B767 LINE MAINTENANCE FORMS MANUAL

REVISION HIGHLIGHTS

REVISION 82, DATED 12-06-10

FIGURE 12

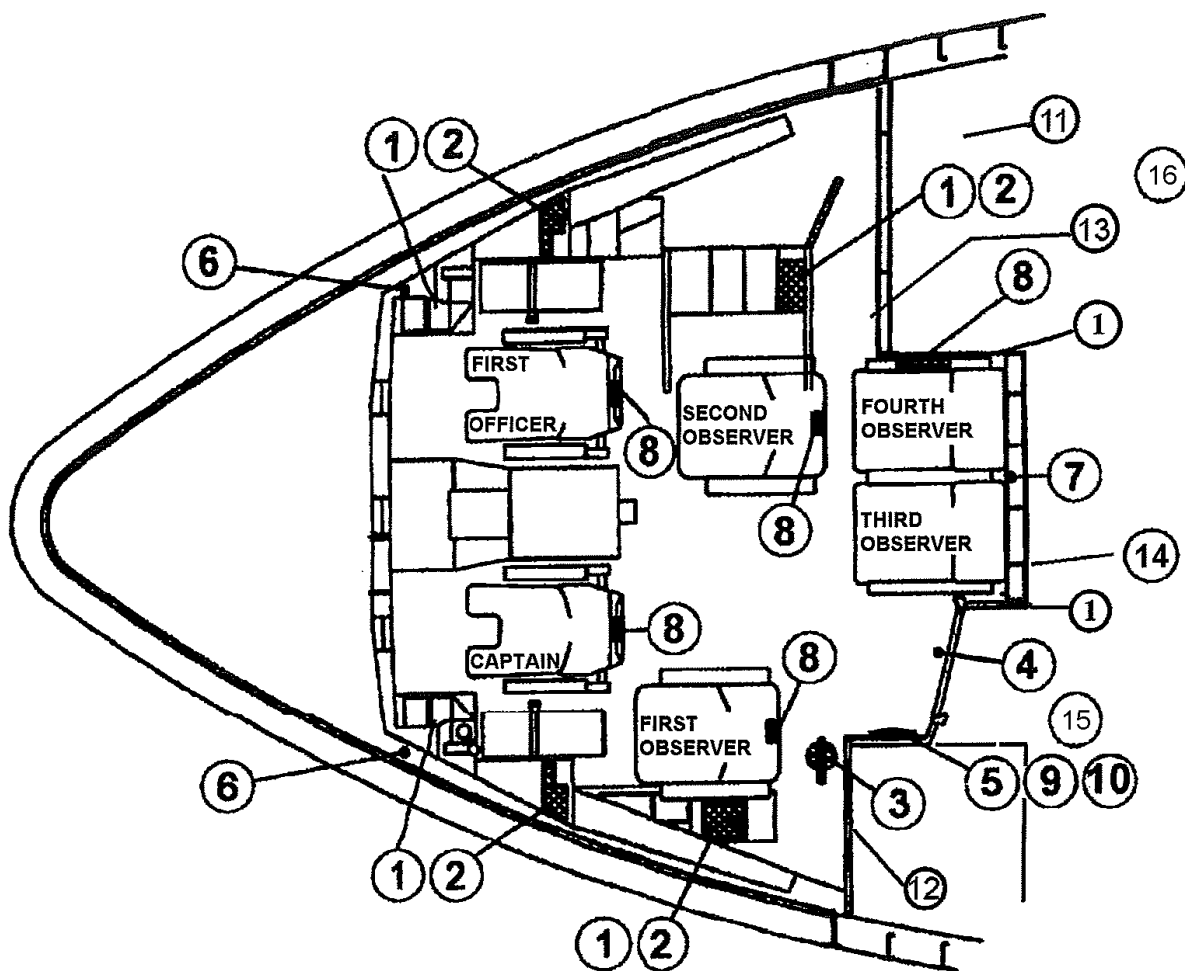
Page 53, revised Figure 13, Sheet 1 of 2, Cockpit Equipment - PC and PC2SF Configured Aircraft, per MPRR 36166.

Page 55, revised Figure 13, Sheet 1 of 2, “Cockpit Equipment - PC Configured Aircraft”, per MPRR 33876.

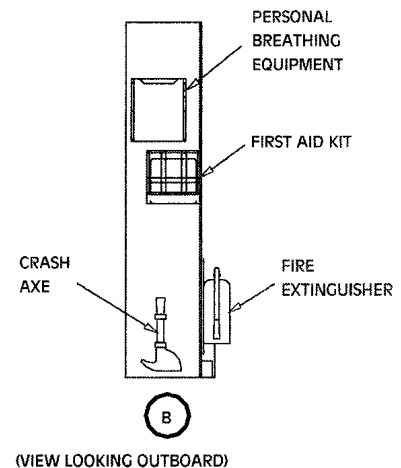
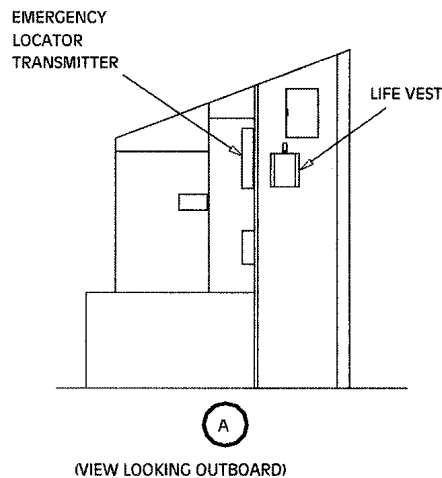
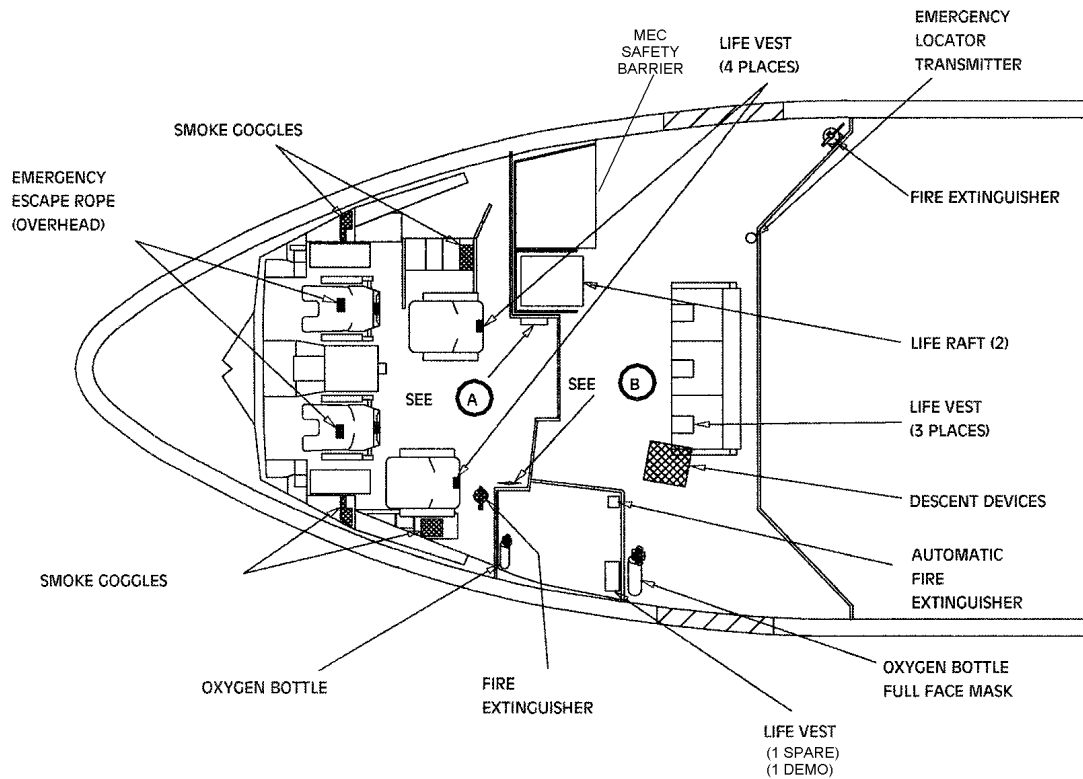
Page 54, revised illustration “Flight Deck Emergency Equipment - SF Configured Aircraft”, Figure 13, Sheet 2 of 2, per MPRR 36216.

PW 4000 ENGINE OIL SERVICING
FIGURE 2

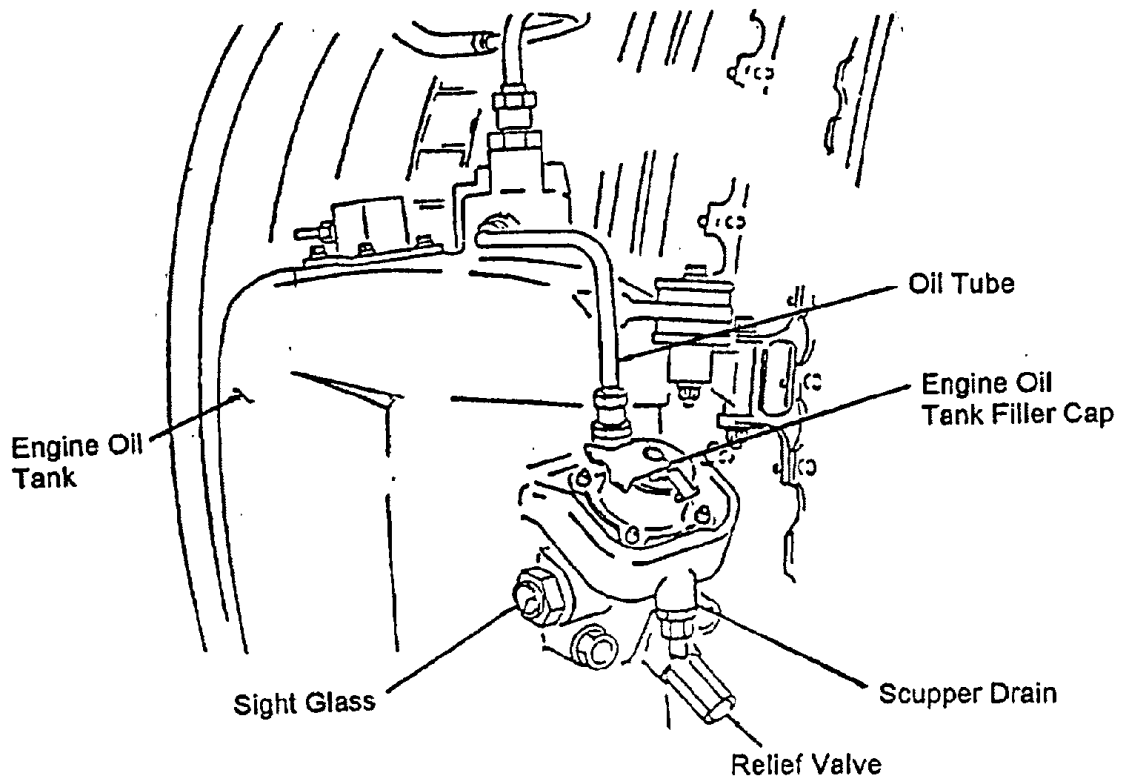
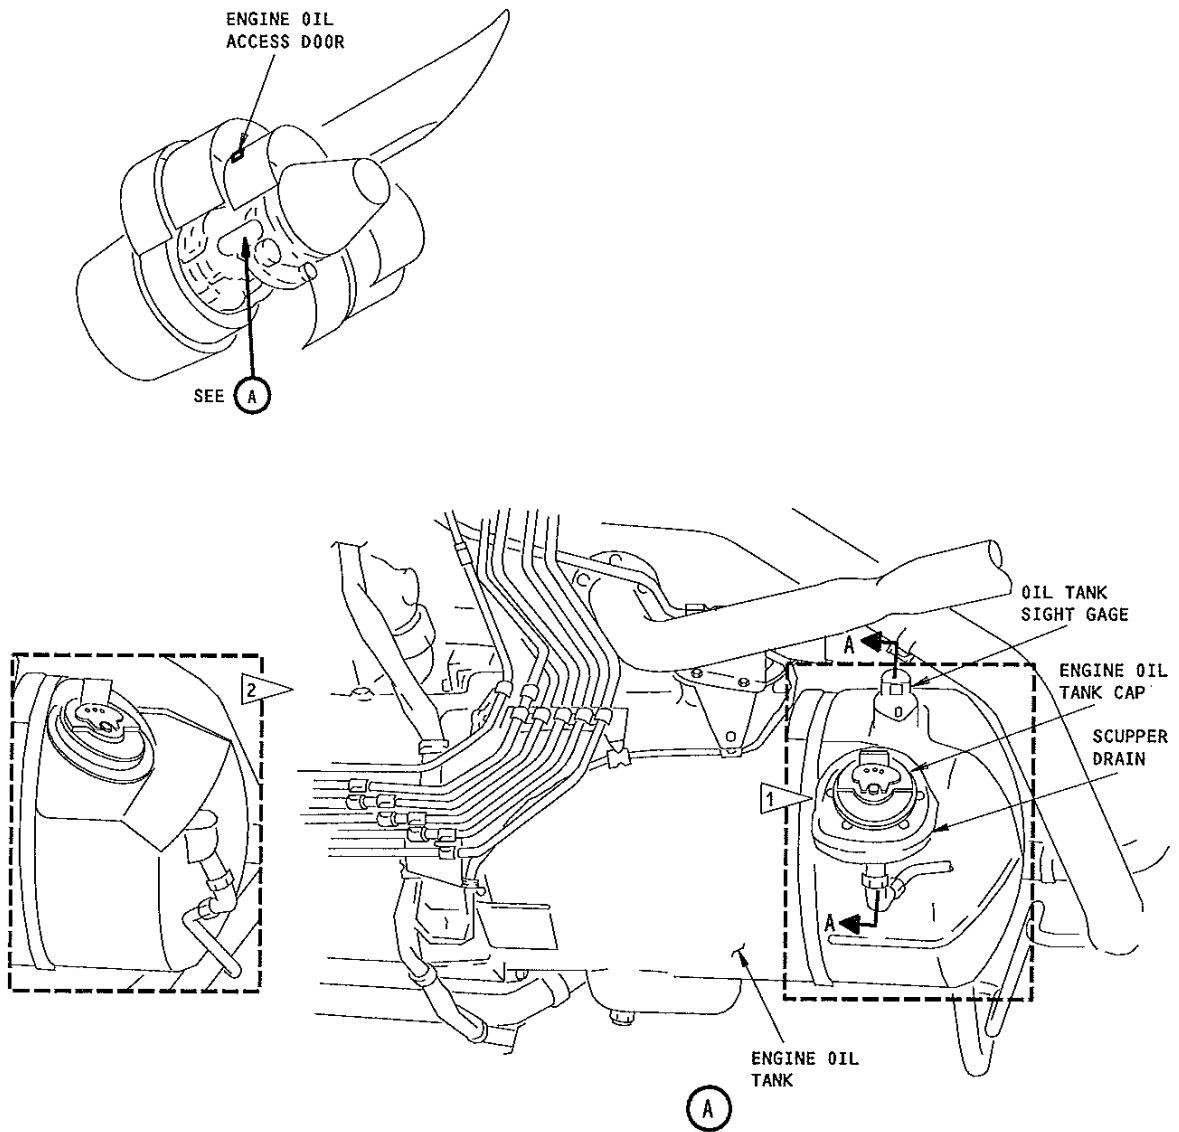
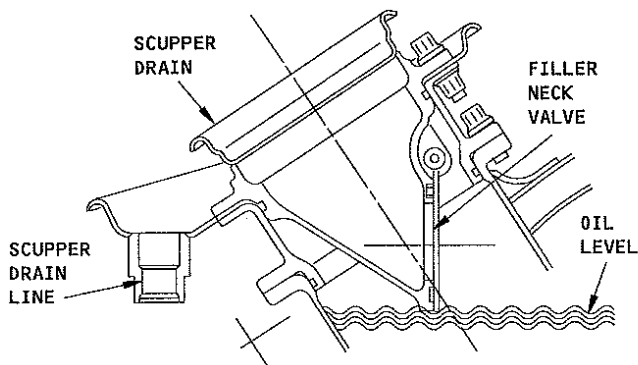
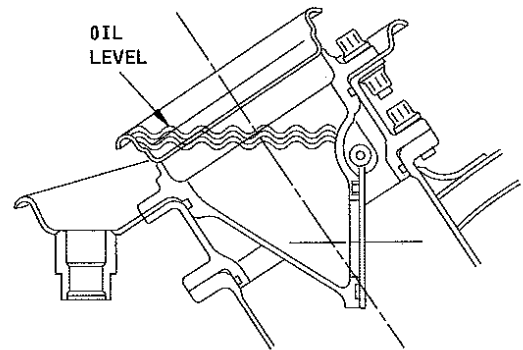
Pages 4-6, added Figures 1, 2, and 3 regarding engine oil servicing, per MPRR 38632.
